Office Action Summary	Application No. 10/595,463	Applicant(s) TAYLOR ET AL.	
	Examiner JIMMY T. NGUYEN	Art Unit 3725

DETAILED ACTION

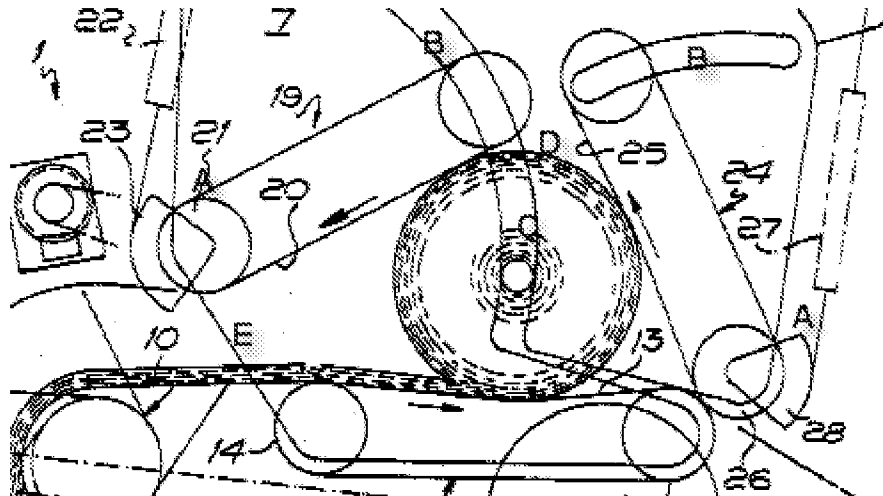
Applicants further argued that the conveyor 19 is not mutually opposed to the conveyor 24, this argument is not found persuasive because figure 3 shows the conveyor 19 is mutually opposed to the conveyor 2 and inclined (fig. 2).

Applicants argued that Pentith does not disclose a material entry region that is mutually displaceable to accommodate increased bale bulk in use (see page 6 of the Applicants' remarks). This argument has been considered. However, claim 1 does not require the material entry region that is mutually displaceable. Additionally, it is unclear how can the entry region be displaced.

Applicants further argued that Pentith fails to disclose "the conveyors mutually displaceable at least at the second ends thereof which form the material entry region to accommodate increased bale bulk in use" and "resiliently biasing the conveyors toward one another at a material entry region to accommodate increased bale bulk in use" (claim 40) because Pentith discloses the material entry point of the baling apparatus is between the first conveyor 19 in the fixed position 12. This argument has been considered. However, since the claims do not specifically define the structural arrangement of the entry region and the claim 1 does not require that the material is entered *through* the entry region, but merely recites the material is deposited *into* the entry region (see claim 1, lines 4-5), the Examiner submits that Pentith discloses the claimed language based on the following interpretation (also see the illustration below for support): "each of the conveyors having a first end (see "A" in the illustration below) and a second end (see "B" in the illustration below), the second ends being arranged to be spaced apart to form a material entry region (see "C" in the illustration below) (the Examiner defines the recitation "a material entry region" as a region for material to enter from an entry (see (E) below) between rollers (14 and 21) (see fig. 2)) into which material to be baled is, in use,

deposited , ... a pinch region (see "D" in the illustration below) , the conveyors being mutually displaceable at least at the second ends thereof which form the material entry region (see figs. 2 and 3). The conveyors resiliently biased towards one another by springs (22 and 27).
